APPLICATION NO.	FILING DATE	FIRST NAMED INVENTOR	ATTORNEY DOCKET NO.	CONFIRMATION NO.
10/717,110	11/19/2003	Richard L. Bontrager	RSVP-03008US0	7308

Office Action Summary

This is the second office action for application number 10/717,100, Modified Spring System End Cap for Packaging Fragile Articles Within Shipping Cartons, filed on November 19, 2003.

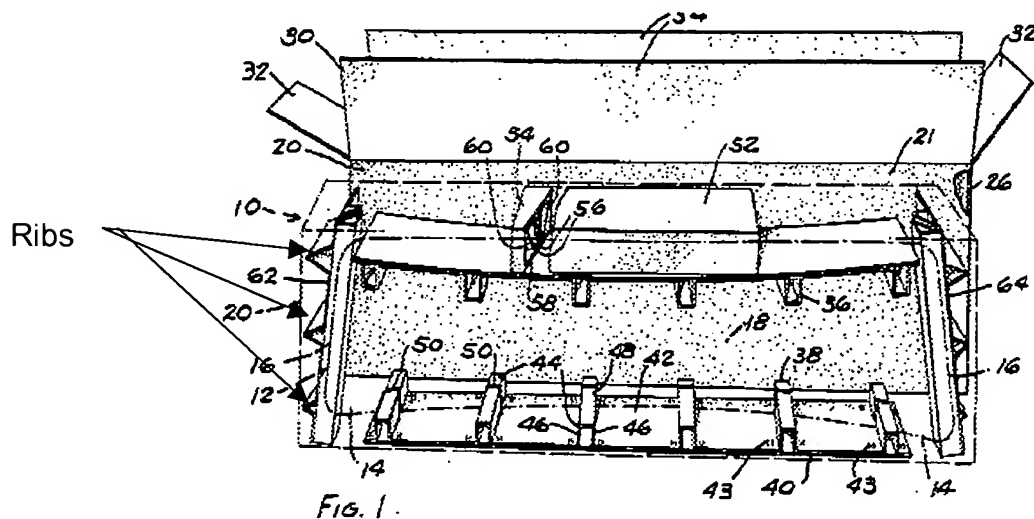
Azelton et al. '796 discloses a spring system end cap (figures 1A, 1B) comprising a platform portion (4), a sidewall structure (6,8) having a length and including an inner wall (10) connected with the platform portion and surrounding the periphery of the platform portion, and an outer wall (12) forming an acute angle relative to the platform portion and surrounding the periphery of the inner wall, at least one spring system (14) connected between the inner wall and the outer wall wherein the spring system includes at least one bellows (20), wherein the sidewall structure includes a plurality of the spring systems formed end to end, wherein each spring system is connected with the outer wall along a ridge forming a plurality of arcs (see figure 1B) connected end to end along

the length of the sidewall structure, wherein Azelton et al. '796 additionally teaches a system for supporting an article including first and second end caps as previously described (see figure 2).

However, Azelton et al. '796 fails to specifically teach at least one rib protruding from the outer wall. Nevertheless, Lidgard '534 divulges an end cap for supporting an article (figures 1,2, see above), wherein the end cap includes ribs (above) protruding from an outer wall. It would have been obvious to one of ordinary skill in the art at the time the invention was made to have included ribs on the outer wall of Azelton et al. '796 as in Lidgard '534 so as to allow the end caps along with an object being held by the end caps to more closely conform to the inside of a carton or box which would provide for a more stable assembly. Further, it would have been obvious to have provided ribs on each of the spring systems so as to provide for an even more stable assembly, in addition to the fact that doing so is simply seen as a duplication of parts.
